REPORT CORRECTED BY STAFF 5-10-90
CITY PLANNING COMMISSION
 1231 "I" STREET, SUITE 200, SACRAMENTO, CA. 95814

- APPLICATION:**
- A. Negative Declaration
 - B. Rezone 6.0± vacant acres from Standard Single Family (R-1{EA-4}) to Single Family Alternative (R-1A{EA-4}) zone
 - C. Tentative Map to divide 6.0± vacant acres into 38 single family lots in the R-1A(EA-4) zone to be called Carnation Garden Village
 - D. Special Permit to construct 38 single family dwellings (petite homes) in the R-1A zone
 - E. Special Permit for a 7% density bonus in a designated infill area
 - F. Section 65402(a) Review for abandonment of various streets and alleys

LOCATION: North side of 57th Avenue between Carnation Avenue and Indian Lane

APPLC. NO. P89-101 **MEETING DATE** May 10, 1990 **ITEM NO** 9

Exhibit A - Tentative Map
(corrected 5-10-90)

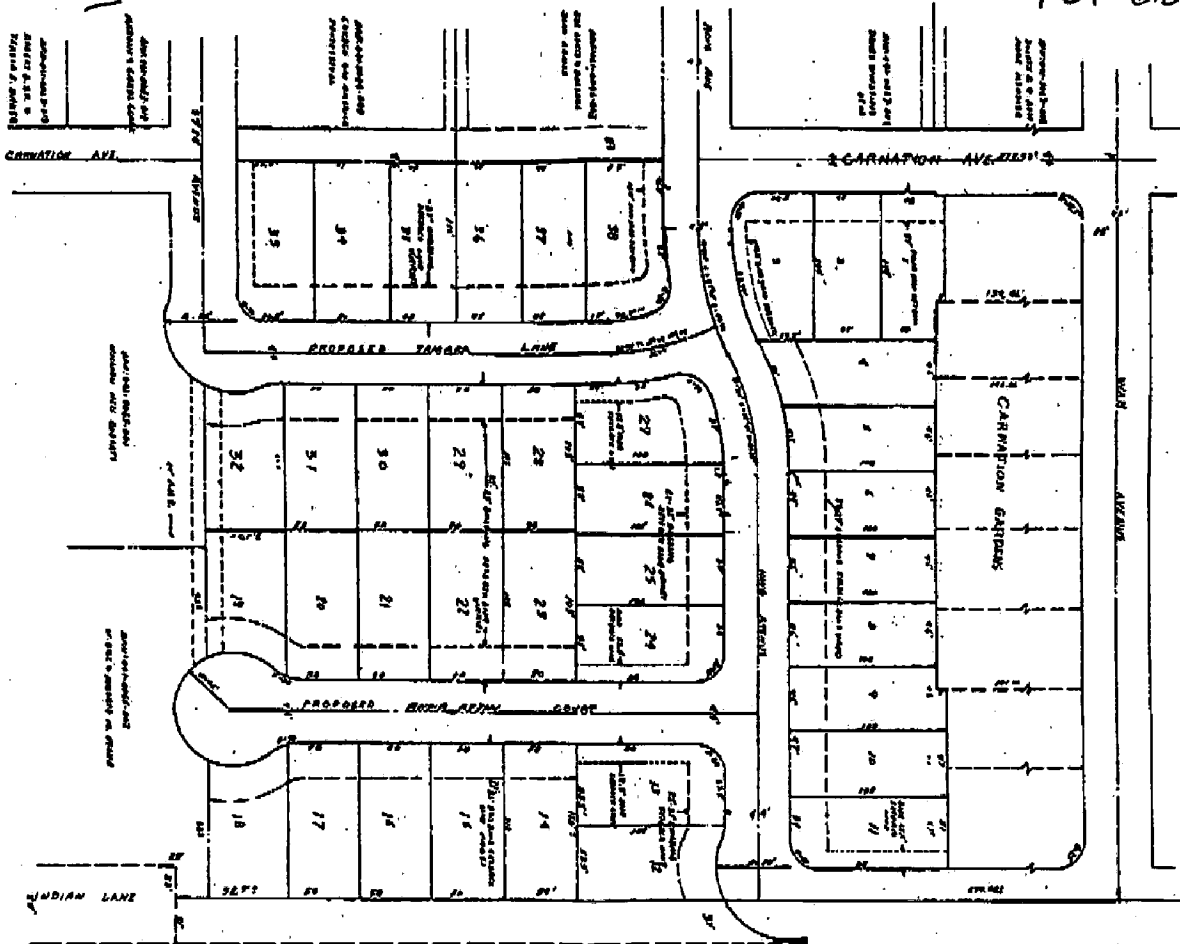
The proposed tentative map shows a looped road system different from the old underlying subdivision which established road and alley rights-of-way through the site. Rather the build-out under the previous lotting pattern with the east-west streets of Hing and 57th Avenue, the removal of portions of the right-of-way and realignment of streets provides adequate circulation based upon the existing ownerships in the area. None of the streets or alleys to be abandoned exist as fully improved streets or alleys. By recording the tentative map and abandoning the previous rights-of-way, the proposed tentative map allows placement of full street improvements and eliminates the need for 20 foot wide alleys.

The tentative map shows building setback lines for all lots. Staff recommends that the final map show recorded building setbacks and any required easements. Driveways shall be a minimum of 20 feet long from the front property line.

- D. A five foot high (relative to pad elevation) barrier shall be provided along the east property line of lots 10-11 and 13-17. The barrier shall extend from the north property line to the front yard setback of lot 10 and from the front yard setback of lot 11 to the south property line of lot 17.

1. Provide standard subdivision improvements pursuant to Section 40.811 of the City Code, including 22 foot half street on Indian Lane between Hing and Wah with 12 feet of pavement northbound east of centerline;

15. Extend off-site water line to the satisfaction of the Water Division;
16. Provide a tangent section between the reverse curves on Hing Avenue to the satisfaction of the Traffic Engineer;

17. Minimum lot sizes shall be 52 feet by 100 feet interior and 62 feet by 100 feet corner lots if not rezoned to R-1A;
18. Show all existing easements to remain following abandonment of various streets and alleys;

20. Dedicate 10 foot water easement along south property line of lot 18;
21. Observe existing 24 inch gas transmission line in east half of Indian Lane. Use extreme caution in area when digging. Possible conflicts with two inch gas lines at Carnation and Wah and Carnation and 57th Avenue; and

ELEVATIONS

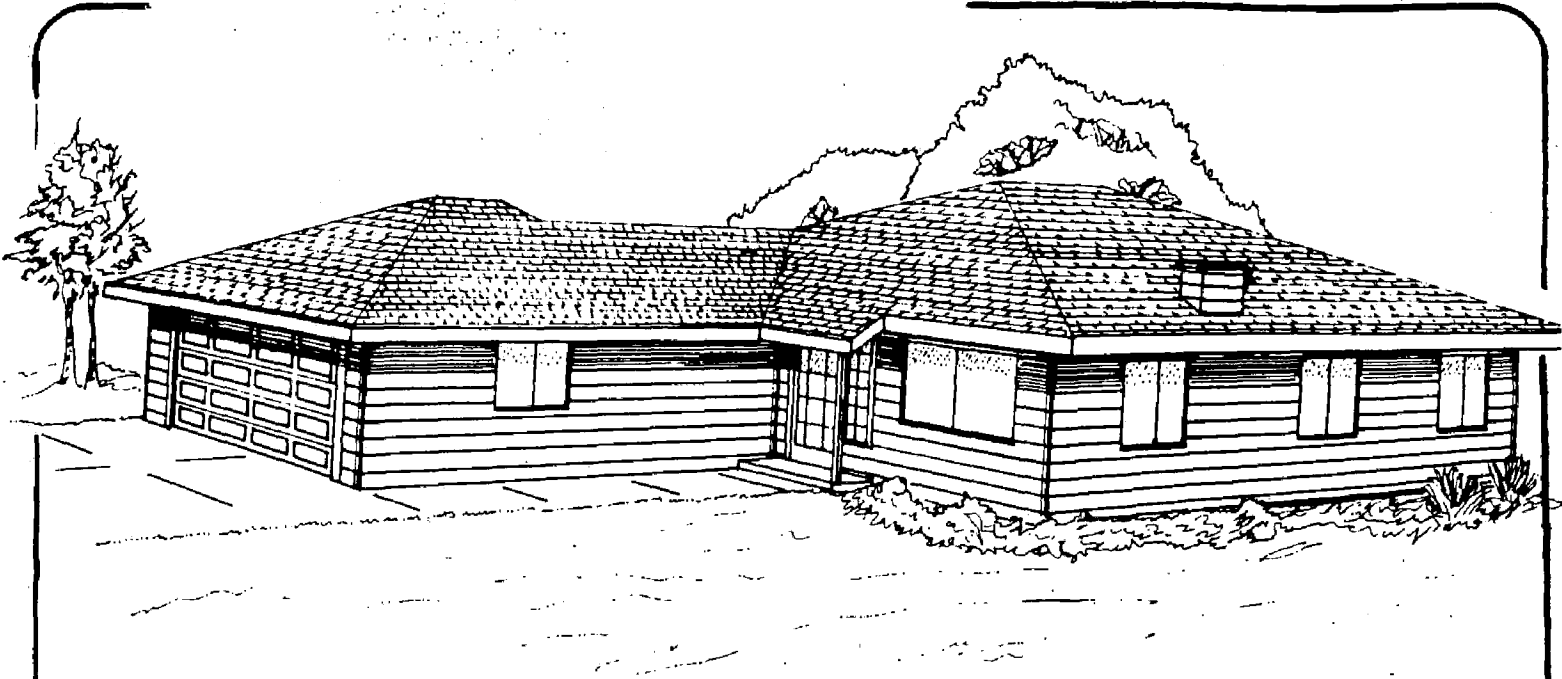
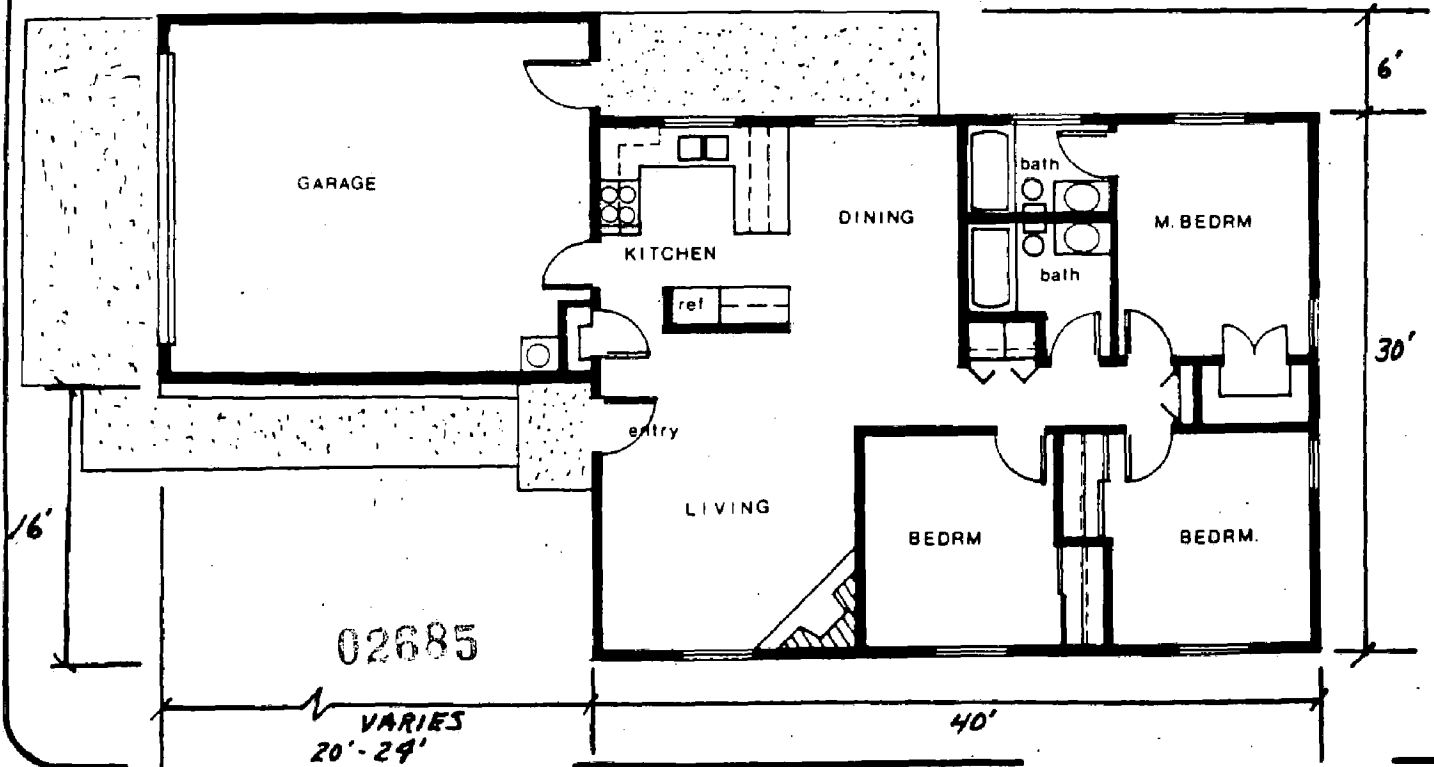
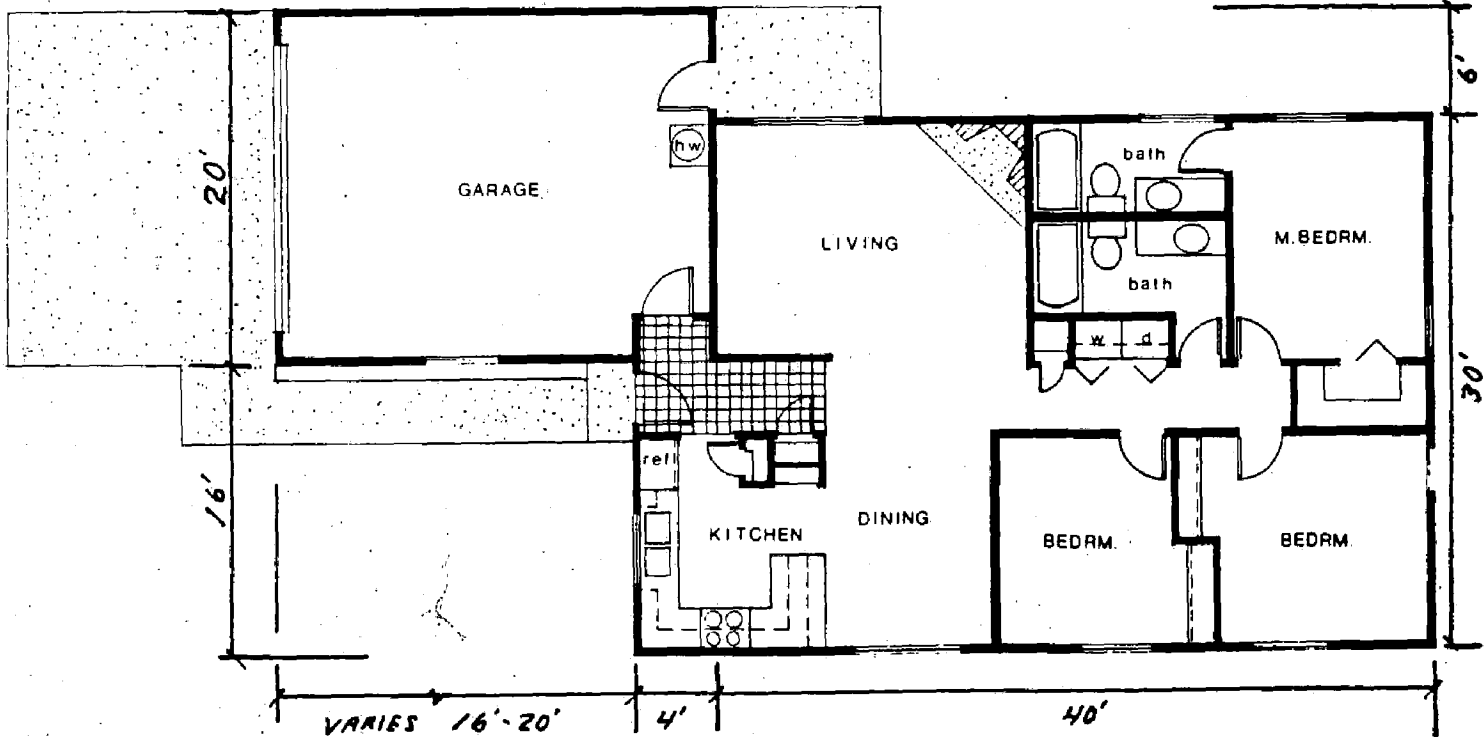
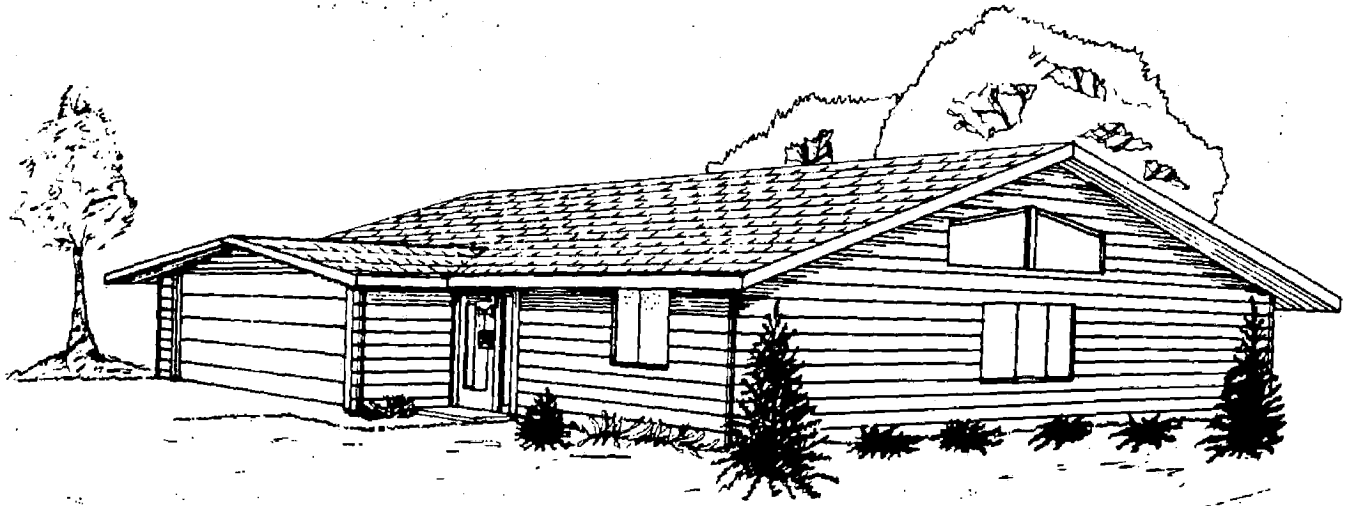
The floor plans provide the kitchen area at the fronts of Plans B and C with the living room at the front of Plan A. Windows facing the street are essential to provide street security. Staff recommends that the elevations be upgraded to include wood trim around windows, some vertical wood or stucco siding with the horizontal siding. Roof material shall be minimum 30 year heavy grade composition asphaltic single with earth tone colors. Use of various colors is recommended to provide variety. Revised elevations are to be reviewed and approved by Planning Division staff prior to issuance of building permits. The applicant or subsequent builder shall construct units as approved under this permit as modified.

1. The final map shall show recorded building setbacks for all proposed lots.
2. No duplex or halfplex units are allowed on corner lots.
3. The Planning Division staff shall review and approve detailed elevations which will show wood trim around windows, some vertical or stucco siding with

horizontal siding prior to issuance of building permits. Roof materials shall be a minimum 30-year heavy grade composition shingles in earth tone colors. Roofs on separate houses shall be a mix of colors to provide variety.

ABANDONMENT EXHIBIT C

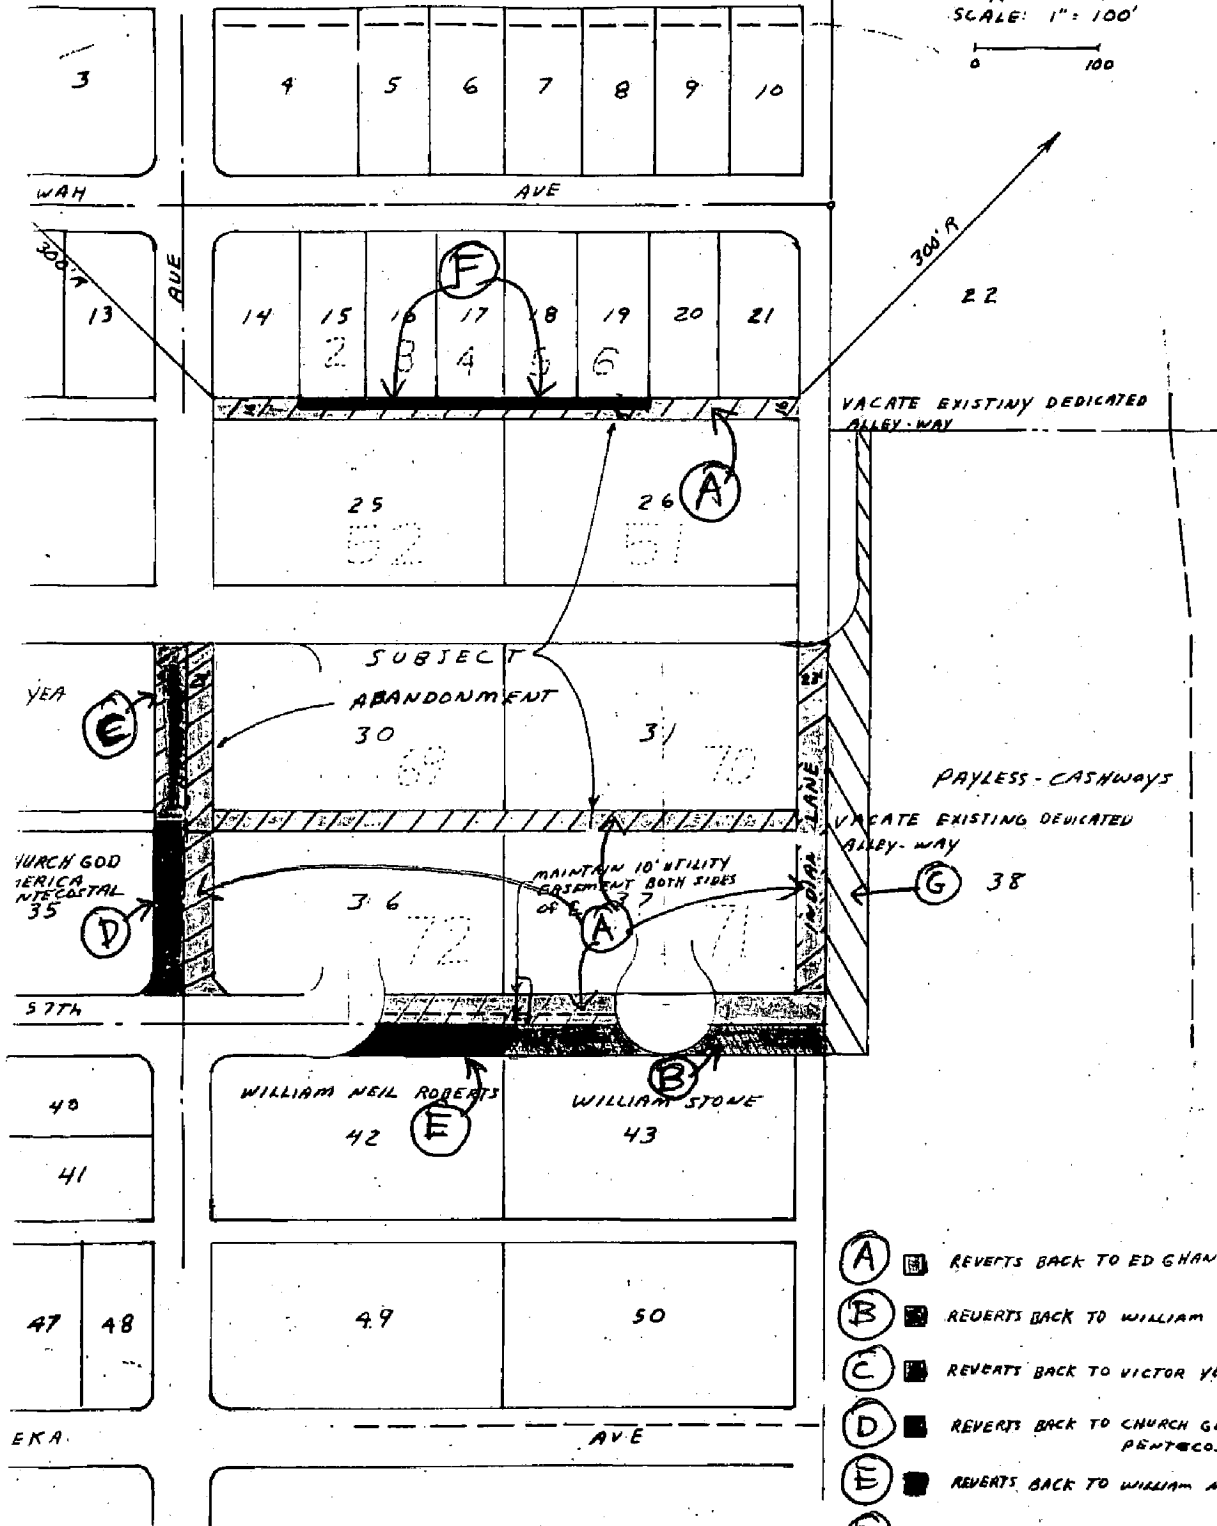
In order to develop the site, abandonment of a series of streets and alleys is required. Exhibits C and D describe the proposed streets and alleys to be abandoned. County Sanitation District requirements will reserve easements for existing facilities. Other utilities have reviewed the proposal and require the relocation of facilities or setting aside the easement. The streets are not part of the circulation element of the 1984 Airport Meadowview Plan. Replacement streets will achieve the appropriate access to lots and provide utilities to each lot. Therefore, as required under Section 65402(a) of the Government Code, staff recommends the Commission find the abandonment consistent with the Community Plan and General Plan.

Adjacent property owners have agreed to accept their portions of alleys or streets to be abandoned. Staff finds the proposed abandonment consistent with the Abandonment Findings of Exhibit E. Refer to Exhibit F, correspondence from responsible agencies regarding the abandonment.

19. Cannot file final map until abandonment proceedings are complete for Carnation Avenue and for alley between Wah and Hing and for 57th Avenue and for Indian Lane;
